FD3 2t prototype activities at CERN

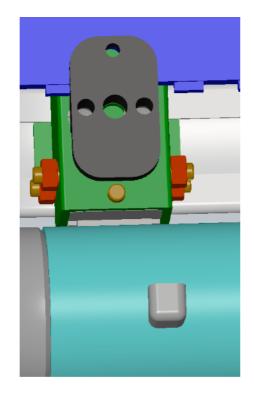
- How the clip is mounted?

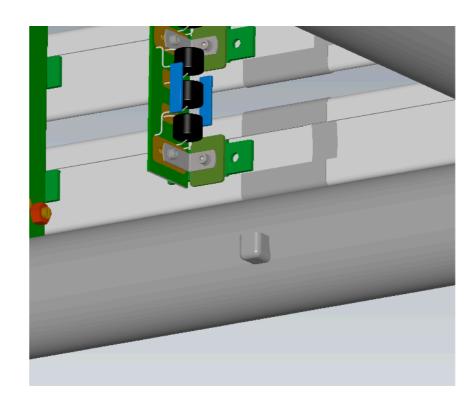
- How the voltage divider is connected to the cathode?
